MEMO

To: Stephanie Moreno, GCRC
From: Eric Donaldson, P.G.
Date: September 13, 2019 rev. 10/24/19

Subject: Silver Creek Linear Park Wetland Study, proposed revised gaging program

Figure 1. Proposed updates to water level gaging program including gaging stations within the Valley Water easement, Silver Creek Linear Park, San Jose, California.

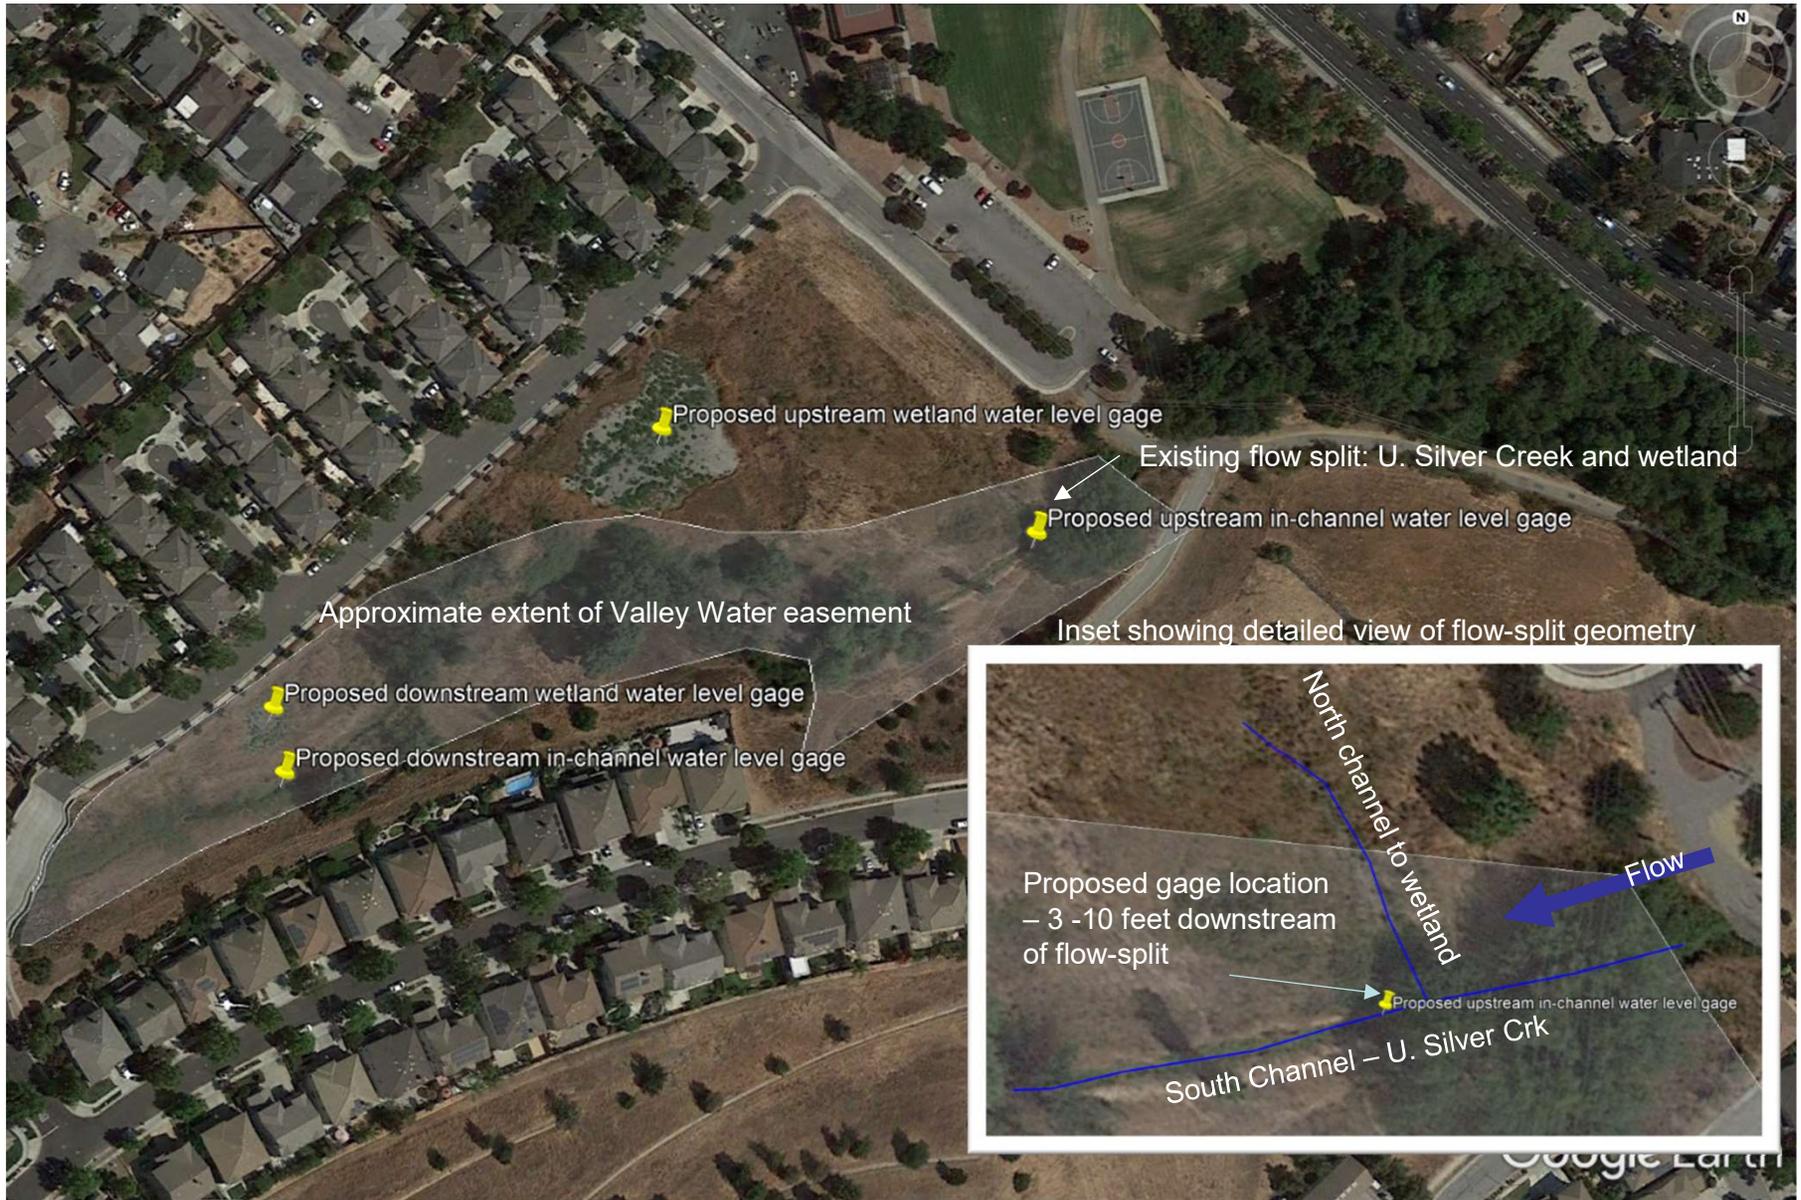
I visited the Silver Creek Linear Park site yesterday to evaluate water gage placement based on feedback received from CDFW. Based on my visit, I have come up with a revised water level gaging plan to evaluate the interactions between Upper Silver Creek and the seasonal wetland features on the right bank at Silver Creek Linear Park. This proposal does not address easement issues but presents a better scenario to evaluate hydrologic interactions between the creek and the wetlands. Please note that the outline in the figure is a Valley Water easement, not a fee title property. If we decide we would like to evaluate the wetland/channel downstream of the main season wetland pan, I would suggest we add another paired set of channel and wetland water level gages. If Valley Water will allow us to do the gaging within their easement but does not want us to include wetland area within their easement in our study, I suggest we remove the two downstream gages and add a second in-channel gage.

Proposed upstream in-channel water level gage: This gage location, within the south channel (Mainstem Upper Silver Creek), approximately 3-10 feet downstream of the flow-split between the north and south channels will capture water levels in Silver Creek. In addition, we will be able to detect and when water levels in the south channel are sufficiently high enough to flow into the north channel and estimate how much flow is draining to the wetland. Proposed site surveys will focus on characterizing the local topography as it relates to project gages. This gage will improve our understanding of water levels as they correlate to the Valley Water Upper Silver Creek gage at Yerba Buena Road. My initial impression is that the flow split is geomorphically unsustainable in its current configuration, and if re-configuration emerges as the preferred option, data collected here will the technical team look at potential design alternatives that will optimize the wetland sustainability (e.g. lowering the berm). I did not walk every section of channel, but at this point, I prefer this location to the concrete feature midway through the reach. Since we are not gaging flow - only stage - at the site, we do not need to have a hardened weir. Rather, it would be more explanatory, in my view, to have a gage in a naturalized section of the channel in a representative cross-section. We would field-fit the gage, once approved, as is our customary practice.

Proposed upstream wetland water level gage: This gage will allow us to see how the upper wetland is correlated to hydrologic inputs and outputs (Flow through the flow split, and over the

berm, rainfall, etc.). These data are necessary to drive our proposed hydroperiod model and will be used in tandem with available rainfall and evapotranspiration data to understand the water balance of the wetland, including potential losses or gains to groundwater.

Proposed downstream wetland water level gage: This gage will allow us to evaluate the patterns of ponding in this area, which is separate from the upper wetland, relative to channel flow inputs, inputs from the upstream wetland, rainfall, as well as outputs.

Proposed downstream in-channel water level gage: This gage would allow us to look at the interaction between the lower section of channel and the lower wetland. This station would also be helpful for looking at design alternatives for the lower area, down the line.
